22 Parking Structure Photovoltaic, Bldg. 254 Project No. FM120188L/986610 Addendum No. 1

ADDENDUM NUMBER 1

UCSB, 22 PARKING STRUCTURE PV PROJECT

AD01

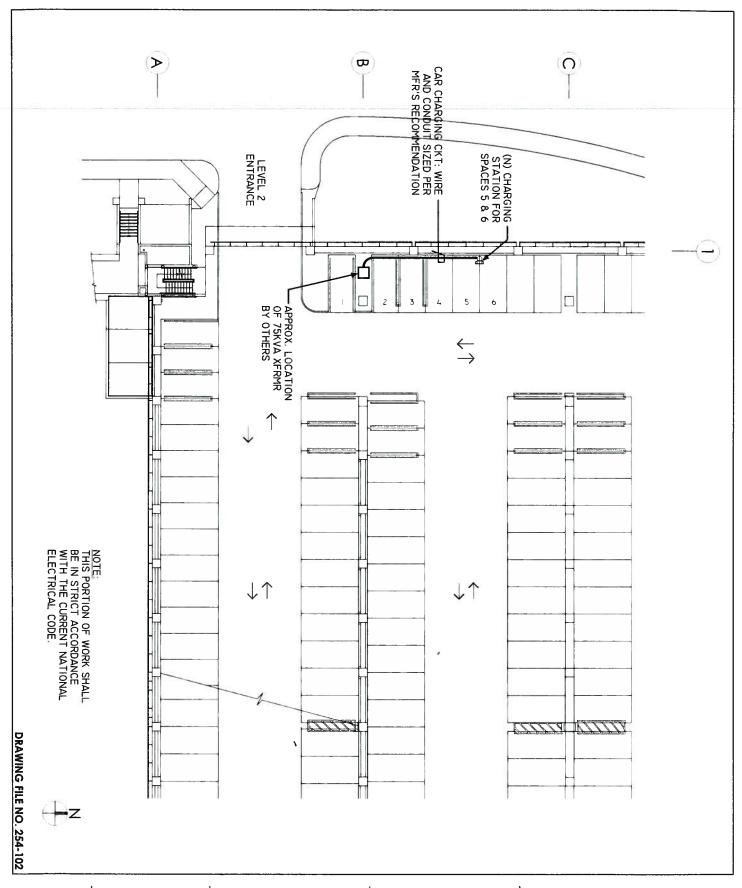
3.8 <u>Sheet E1.1, **DELETE** following items referring to charging station:</u> Charging station conduit run, 45KVA transformer and sub panel.

See Attached Sheet No. AD01 for new Charging Station location on Level 2.

ADDENDUM 1-A: CAR CHARGING PLAN, LEVEL 2 Project
